Notice

☒ PRODUCTION CHANGE
☐ ADD INFORMATION

Model: **DP15647**

Effective from : Chassis No. **P15647-06**

2. IN THE CHASSIS ELECTRICAL PARTS LIST MAIN PC BOARD AND MISCELLANEOUS

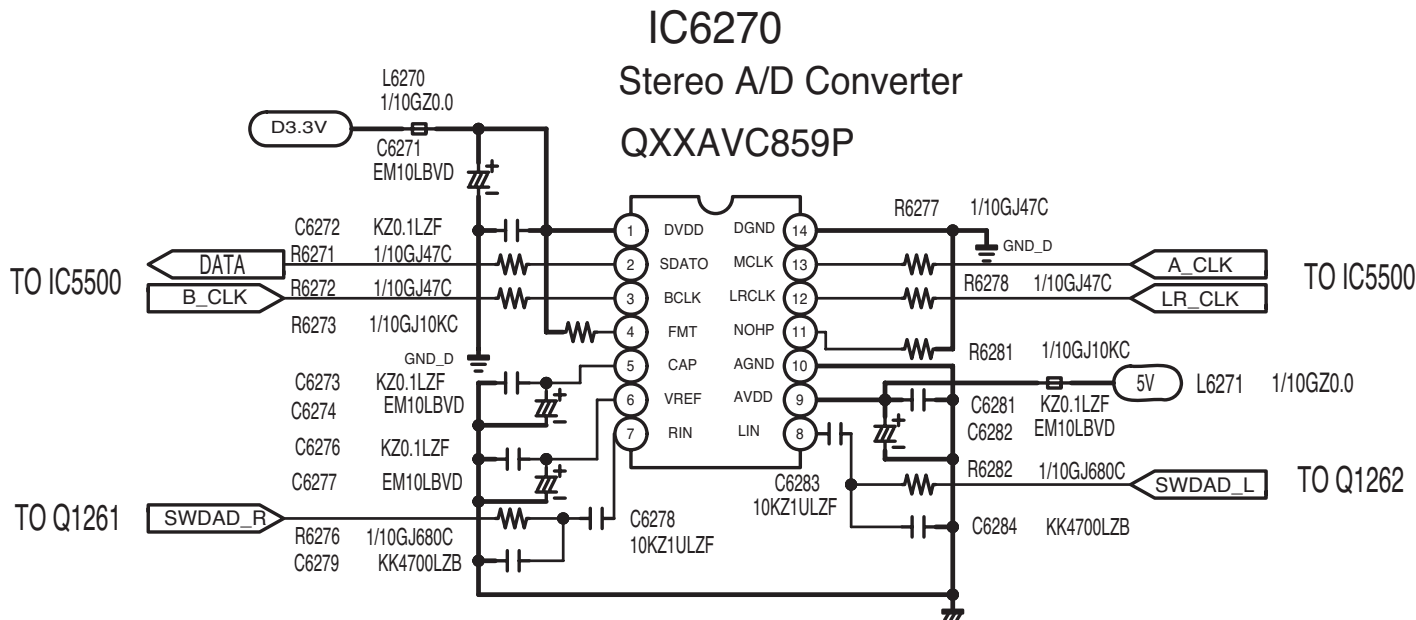
Page & Section	Schematic Location		Part No.	Description	Q'ty	Interchange-ability	Reason
Page 21 Chassis Electrical Parts List	R1263	Old	RGFR000ZTCANL	MT-GLAZE 0.000 JA 1/10W	1	NO	D
		New	RGF1001JTCANL	MT-GLAZE 1K JA 1/10W	1	NO	
	R1266	Old	RGF2201JTCANL	MT-GLAZE 2.2K JA 1/10W	1	NO	D
		New	RGF1001JTCANL	MT-GLAZE 1K JA 1/10W	1	NO	
	R1269	Old	RGFR000ZTCANL	MT-GLAZE 0.000 JA 1/10W	1	NO	D
		New	RGF1001JTCANL	MT-GLAZE1K JA 1/10W	1	NO	
	R1271	Old	RGF2201JTCANL	MT-GLAZE 2.2K JA 1/10W	1	NO	D
		New	RGF1001JTCANL	MT-GLAZE 1K JA 1/10W	1	NO	
Page 24 Chassis Electrical Parts List	A001	Old	1AA0B10N222F0	ASSY, PWB, MAIN	1	NO	D
		New	1AA0B10N23500	ASSY, PWB, MAIN	1	NO	
	△EL901	Old	1AV4T40B83400	LCD (CLAA150XP03)	1	NO	D
		New	1AV4T40B75300	LCD (T150XG01 V2)	1	NO
